SUBMIT IN TRIPLICATE - Other instructions on page 2 7. If Unit or CA/Agreement, Name and/or N 8. Well Name and No. BONNIE 35 FEDERAL COM 4H 9. API Well No. 30-01-54-3619-00-X1	SUNDRY	141011410120070					
Type of Well Gas Well Onter Section	Do not use this form for proposals to drill or to re-enter an abandoned well. Use form 3160-3 (APD) for such proposals.			6. If Indian, Allottee or Tribe Name

Multibowl Wellhead Conditions of Approval

Cactus Multi-Bowl Wellhead Steps:

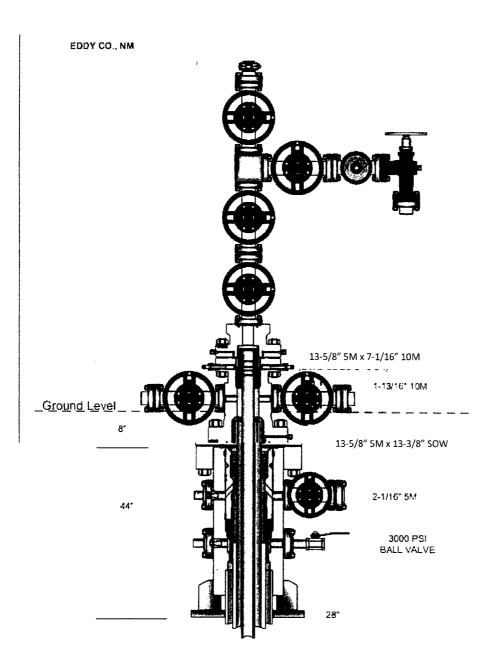
Note: We will not Test BOP's after welding on the Surface head unless we exceed the 30 day limit per Onshore Order #2.

- 3. Operator has proposed a multi-bowl wellhead assembly. This assembly will only be tested when installed on the surface casing. Minimum working pressure of the blowout preventer (BOP) and related equipment (BOPE) required for drilling below the surface casing shoe shall be 3000 (3M) psi.

- a. Wellhead shall be installed by manufacturer's representatives, submit documentation with subsequent sundry.
 - b. If the welding is performed by a third party, the manufacturer's representative shall monitor the temperature to verify that it does not exceed the maximum temperature of the seal.

- c. Manufacturer representative shall install the test plug for the initial BOP test.
 - d. Operator shall perform the intermediate casing integrity test to 70% of the casing burst. This will test the multi-bowl seals.

- e. If the cement does not circulate and one inch operations would have been possible with a standard wellhead, the well head shall be cut off, cementing operations performed and another wellhead installed.
